STATE OF HAWAII
DEPARTMENT OF TRANSPORTATION
HIGHWAYS DIVISION
UTILITY PLAN
MAUNA KEA MAINTENANCE
BASEYARD
DANIEL K. INOUE HIGHWAY
Project No. 200A-01-10
Scale: As Shown Date: April, 2018

1	06-07-18	ADDENDUM NO. 4	
REVISION	DATE	DESCRIPTION	AA15

STATE OF HAWAII
DEPARTMENT OF TRANSPORTATION
HIGHWAYS DIVISION
SHOP BUILDING
MAUNA KEA MAINTENANCE BASEYARD
DANIEL K. INOUE HIGHWAY
Project No. 200A-01-10

MA1.2

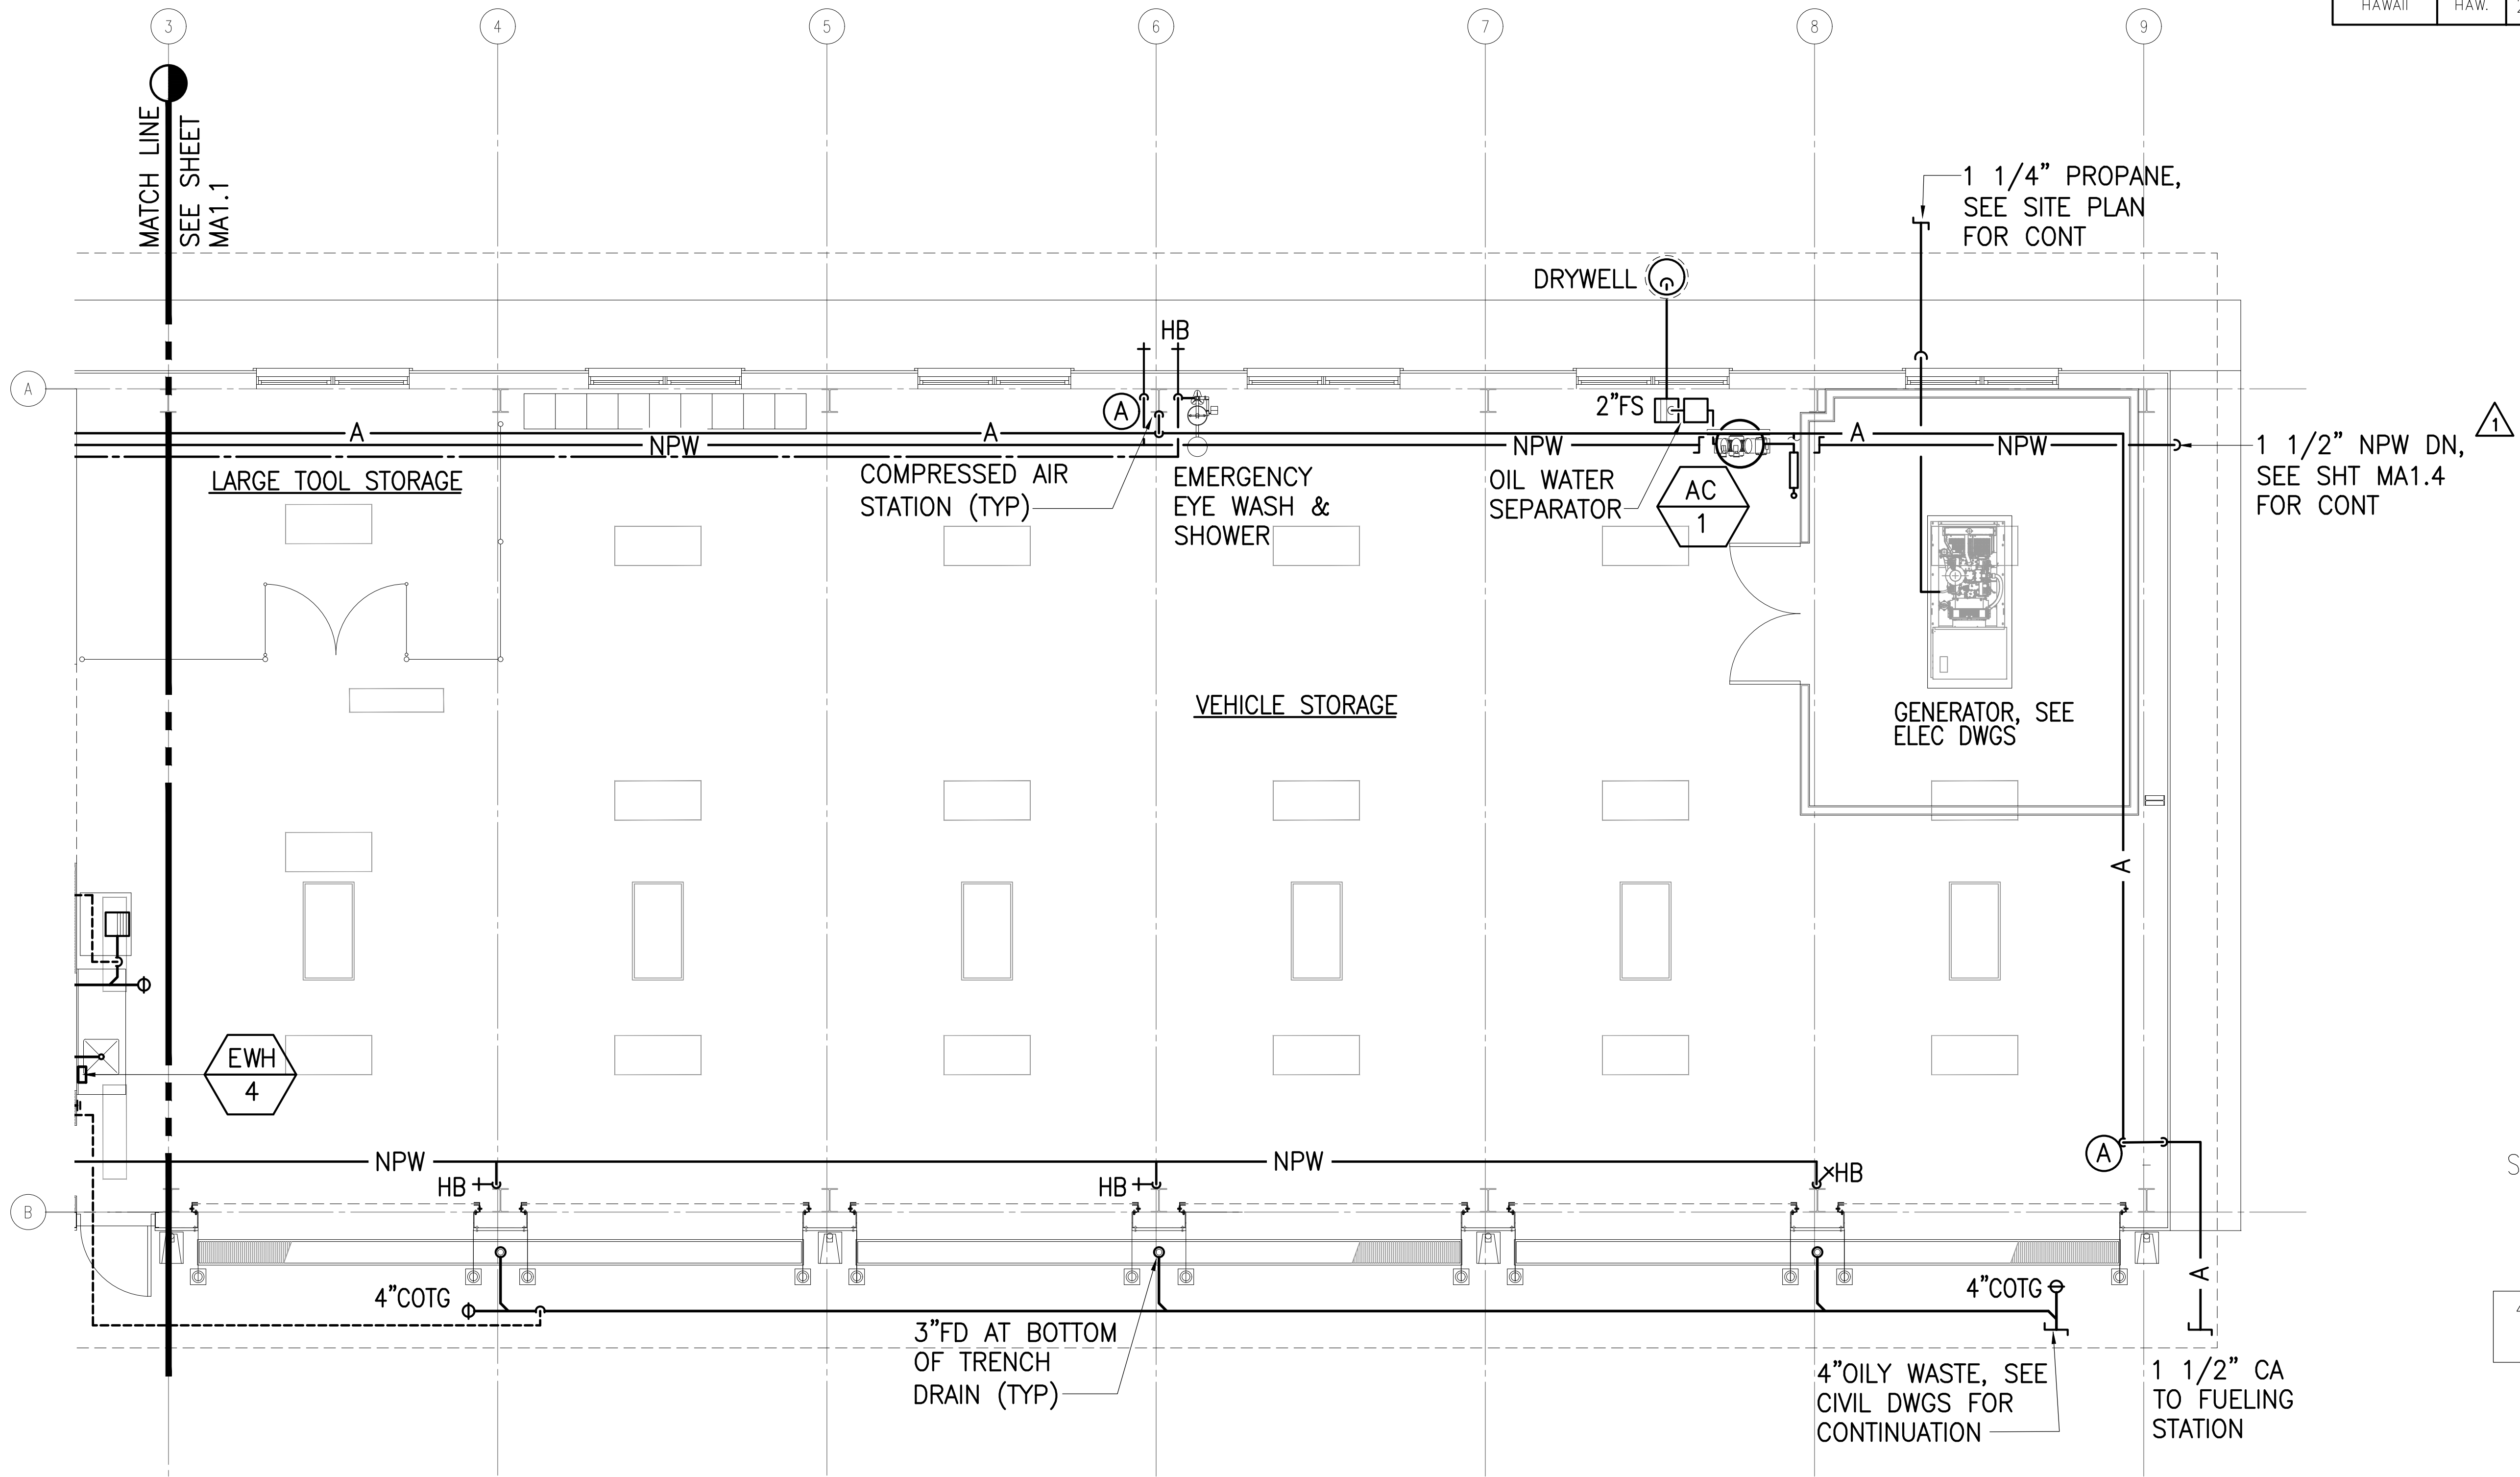
06-07-18	1	REVISED NPW PIPING LAYOUT
DATE	REVISION	
STATE OF HAWAII DEPARTMENT OF TRANSPORTATION HIGHWAYS DIVISION <u>SHOP BLDG PLUMBING</u> <u>MAUNA KEA MAINTENANCE</u> <u>BASEYARD</u> <u>DANIEL K. INOUE HIGHWAY</u> <u>Project No. 200A-01-10</u>		
Scale: As Noted		Date: April 2018
SHEET No. MA1.2 OF 19		SHEETS

MA1.4

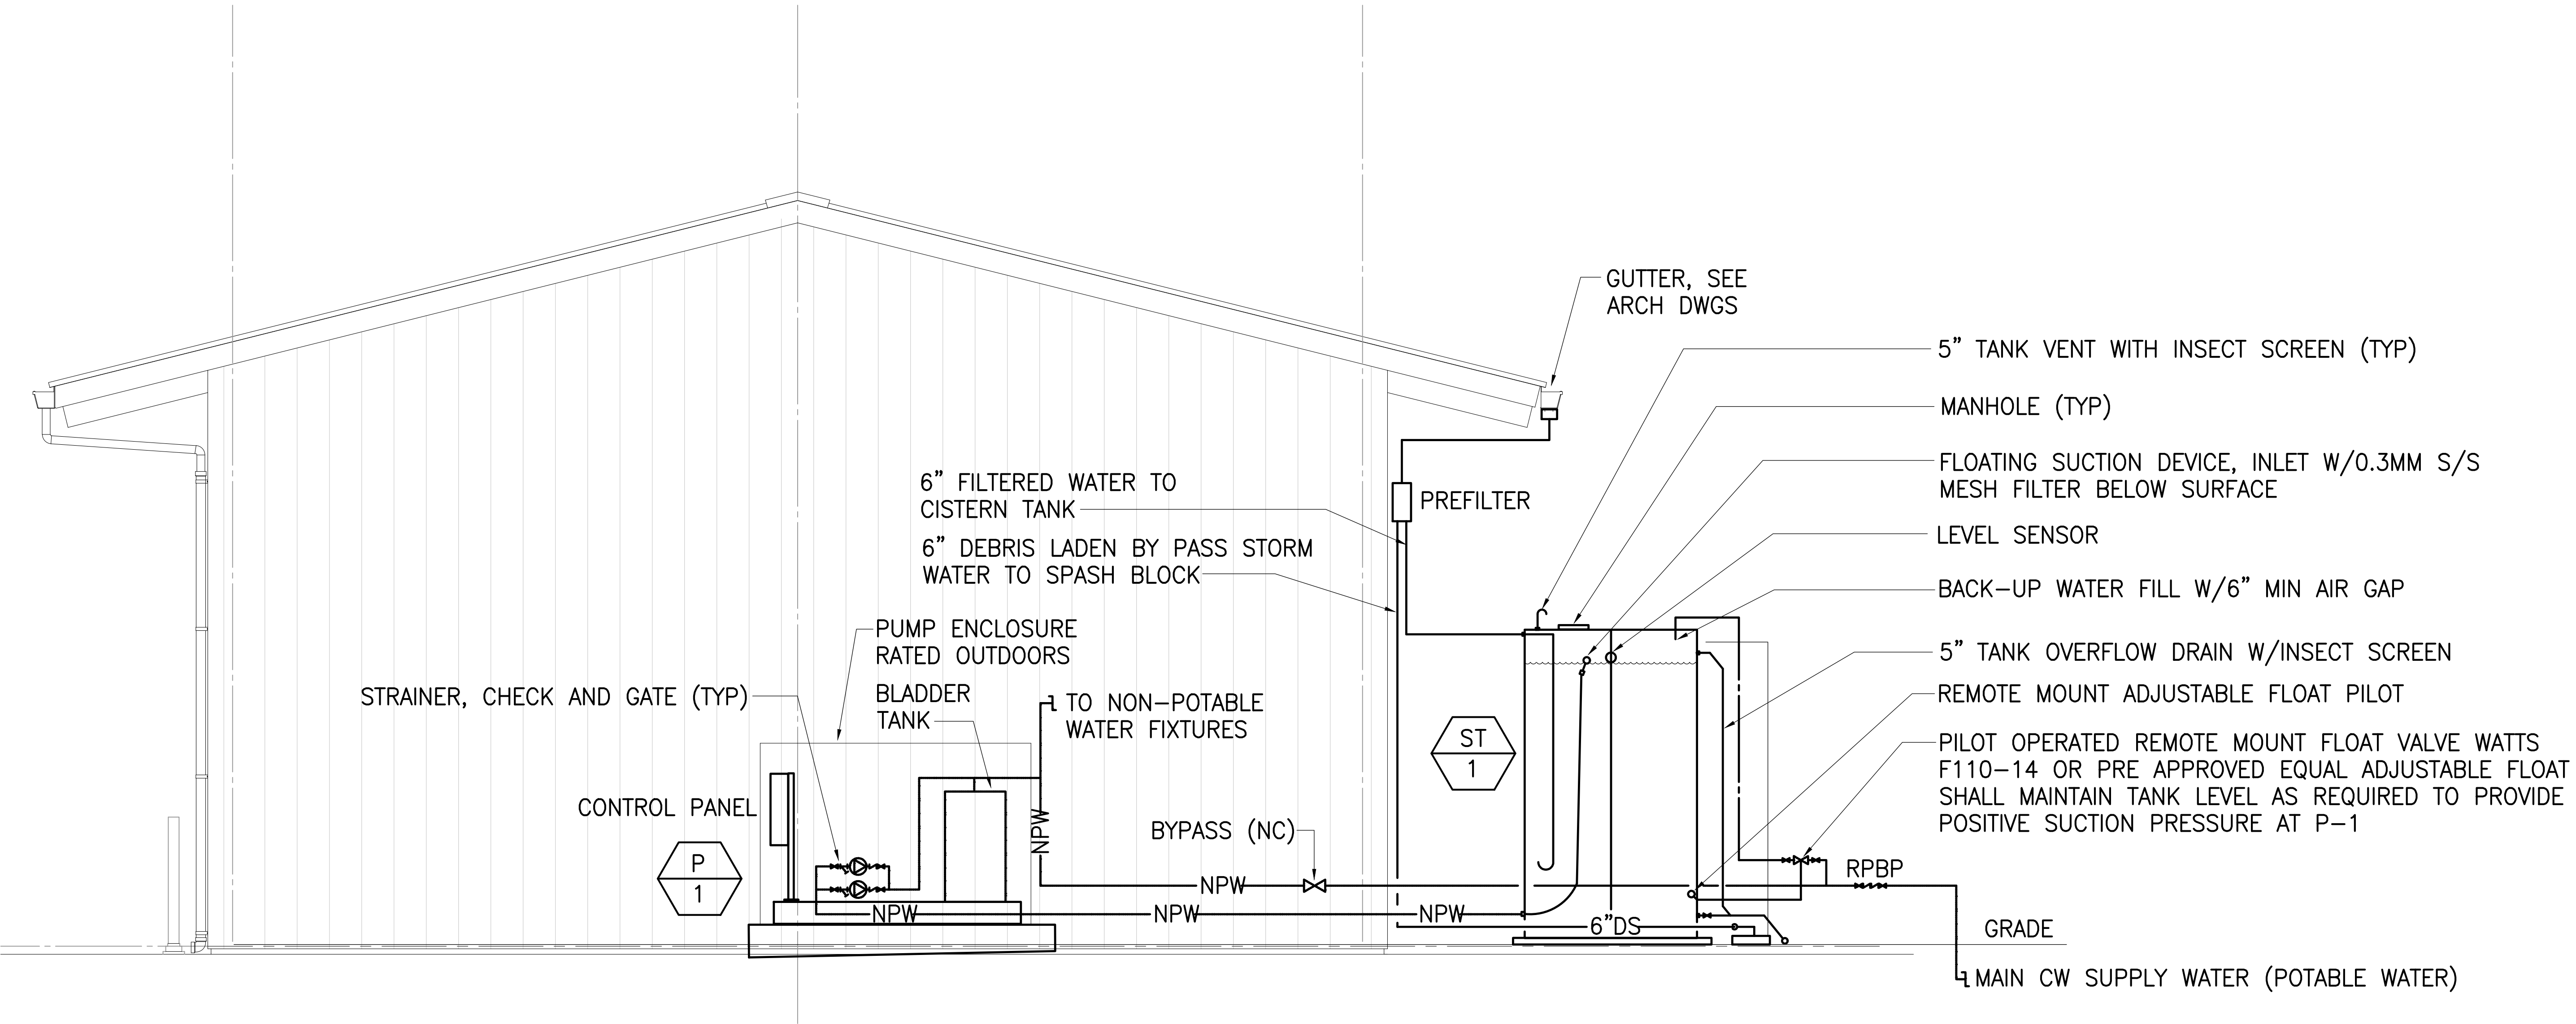
06-07-18	1	REVISE EQUIPMENT NO. P-1
DATE	REVISION	
STATE OF HAWAII DEPARTMENT OF TRANSPORTATION HIGHWAYS DIVISION SHOP BUILDING RAINWATER COLLECTION SCHEMATIC MAUNA KEA MAINTENANCE BASEYARD DANIEL K. INOUE HIGHWAY Project No. 200A-01-10 Scale: As Noted Date: April 2018 SHEET No. MA1.4 OF 19 SHEETS

- 1 P 1** ENGINEERED PACKAGED DUPLEX VARIABLE SPEED DOMESTIC WATER BOOSTER PUMP, 20 GPM AT 50 PSI BOOST, GRUNDFOS SERIES CR, MODEL CR 3-7, CAST IRON, SS FITTED, MECHANICAL SEAL, VERTICAL MULTISTAGE PUMP COUPLED TO A 1.5 HP, 3600 RPM, 460/3/60, TEFC PREMIUM EFFICIENT MOTOR, NON-SLAM CHECK VALVE, ISOLATION LUG STYLE BUTTERFLY VALVE, PRESSURE GAUGES WITH ISOLATION VALVES, NON-ELECTRIC COMBINATION TEMPERATURE PROBE/PURGE ASSEMBLY, UL LISTED NEMA 1 POWER AND CONTROL PANEL, SS SUCTION AND DISCHARGE PIPING, 4.4 150# NON-ASME TANK SKID MOUNTED, NSF-61/NSF 372 COMPLIANT SYSTEM AND OUTDOOR ENCLOSURE. TIGERFLOW SERIES VMD-4000-MB-VFD, TIGERCUB MODEL SVMV-1.5GF-S3-S2-VM-P-VFD, UL/C-UL LISTED OR APPROVED EQUAL.

MA3.1

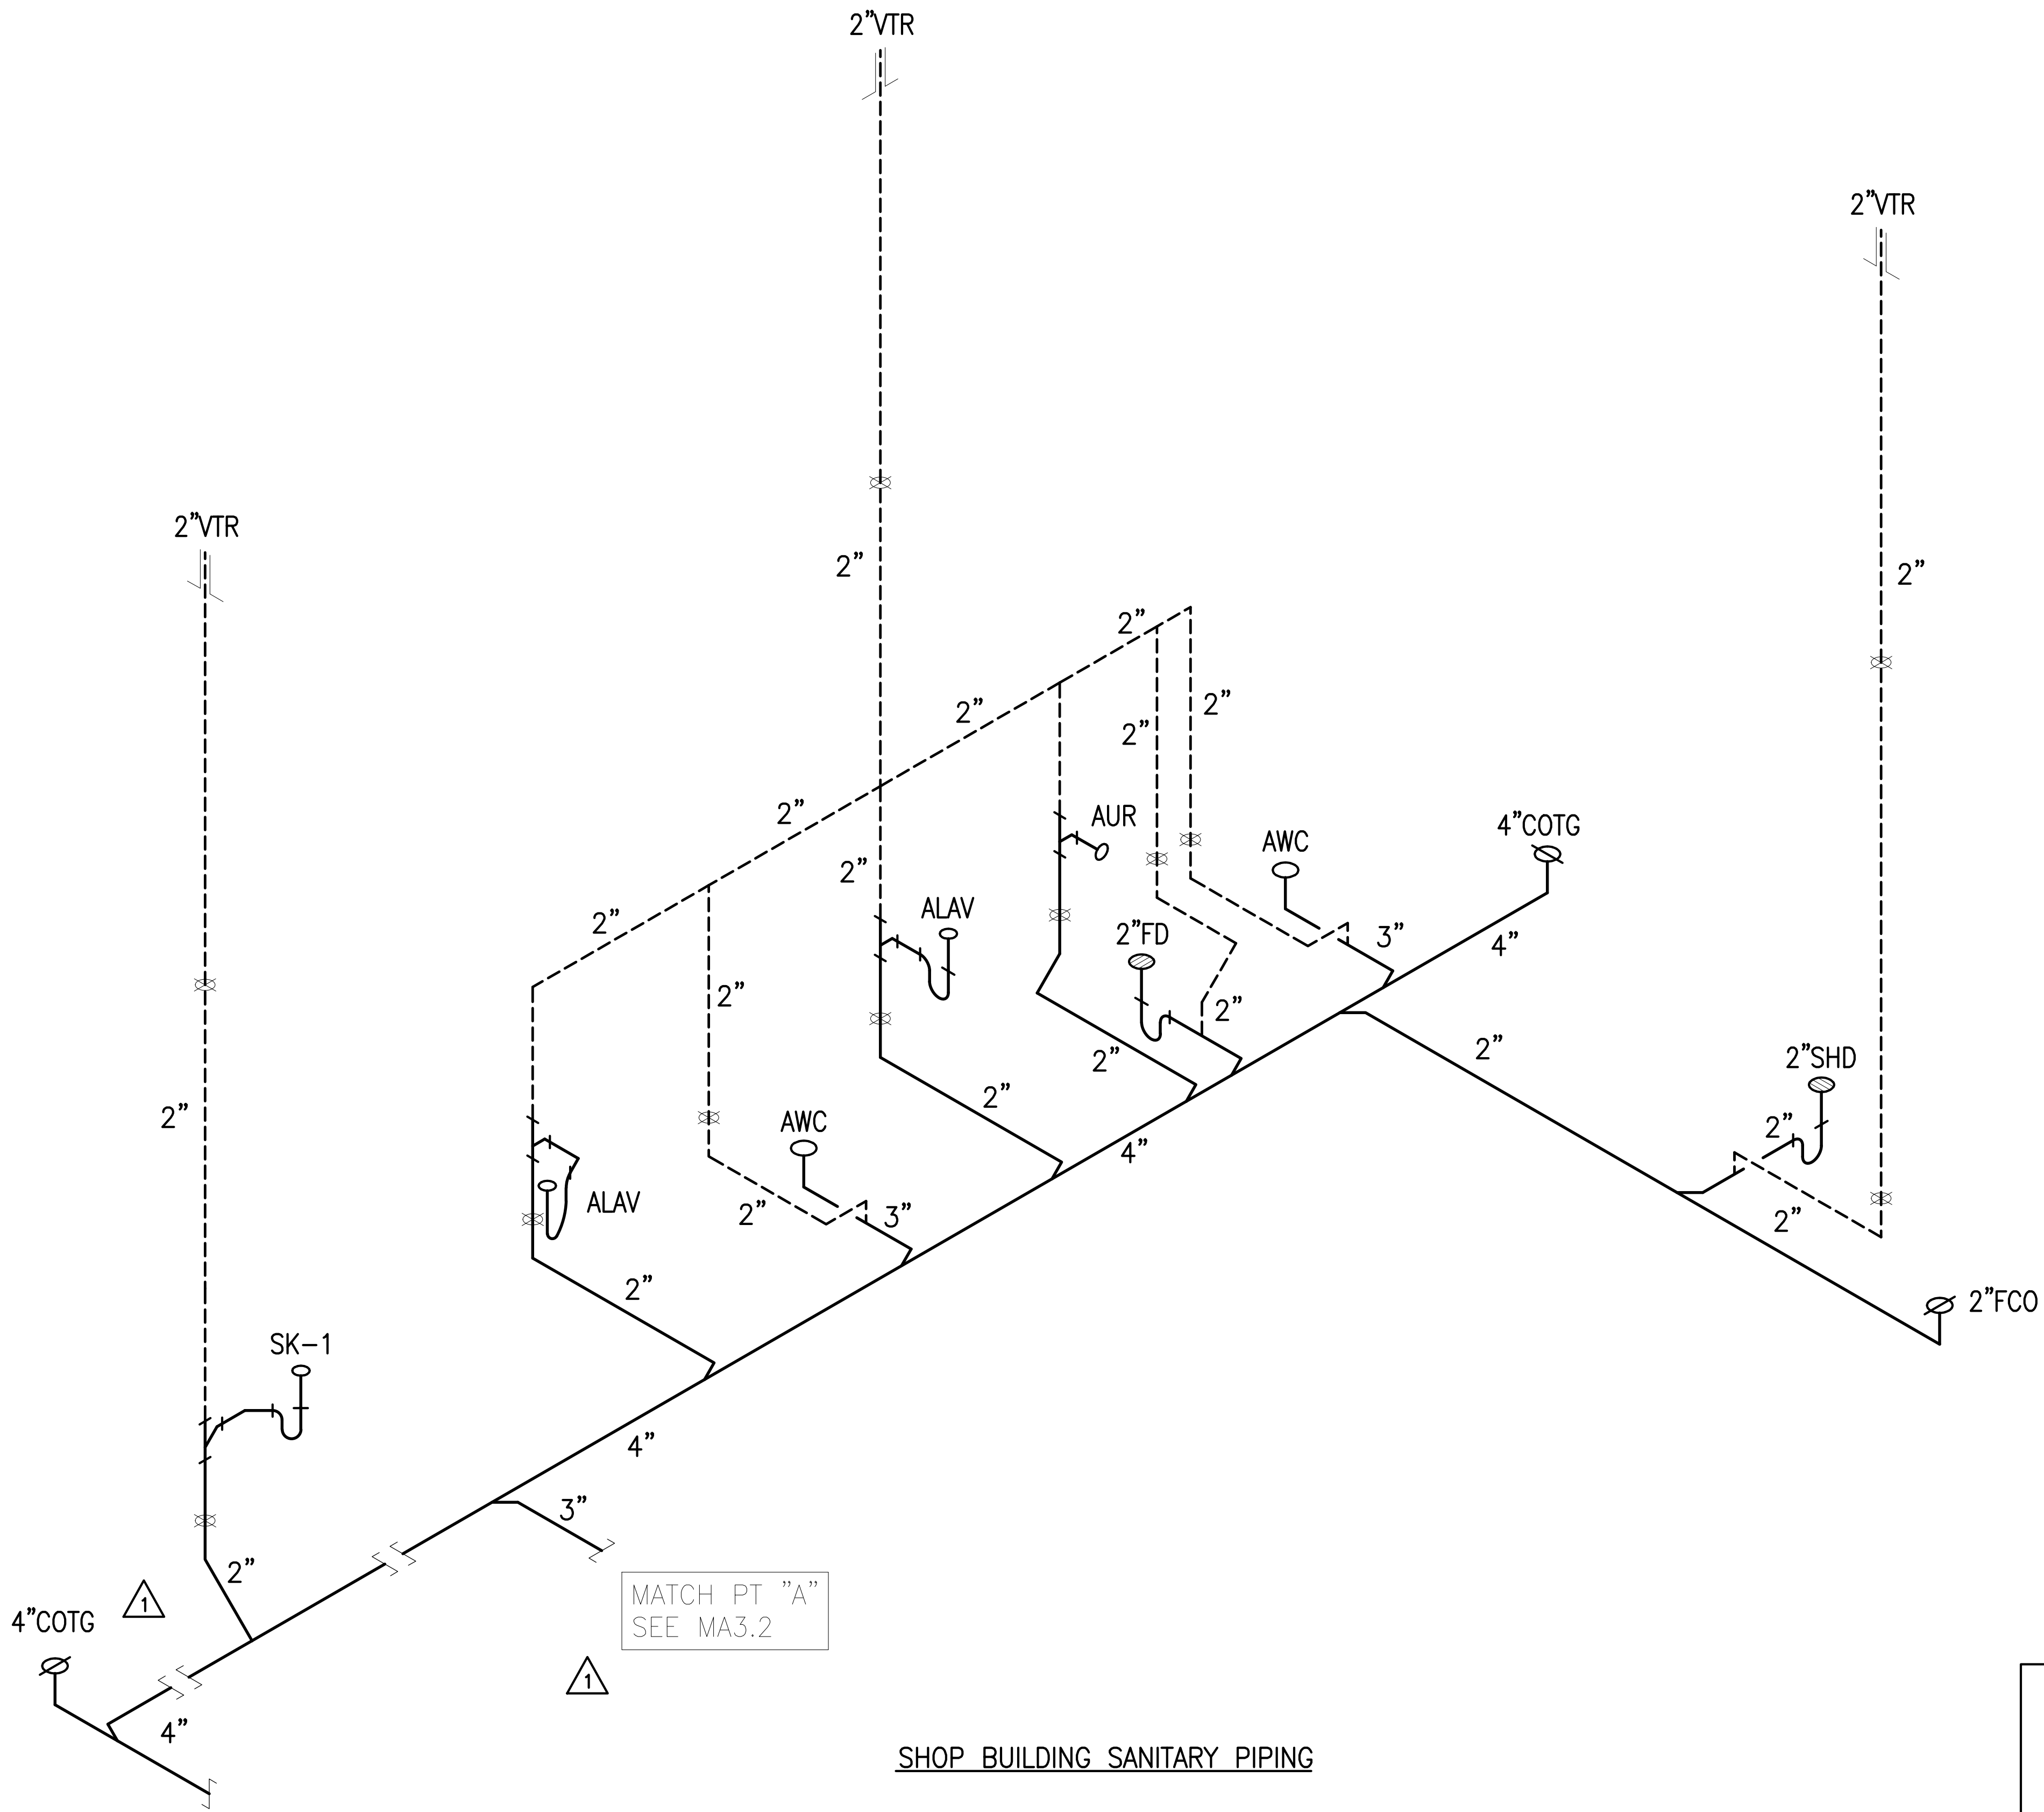
06-07-18	1	REVISED DIAGRAM & ADDED NOTES
DATE	REVISION	
STATE OF HAWAII DEPARTMENT OF TRANSPORTATION HIGHWAYS DIVISION <u>DIAGRAMS</u> <u>MAUNA KEA MAINTENANCE</u> <u>BASEYARD</u> <u>DANIEL K. INOUE HIGHWAY</u> <u>Project No. 200A-01-10</u>		
Scale: As Noted		Date: April 2018
SHEET No. MA3.1 OF 19 SHEETS
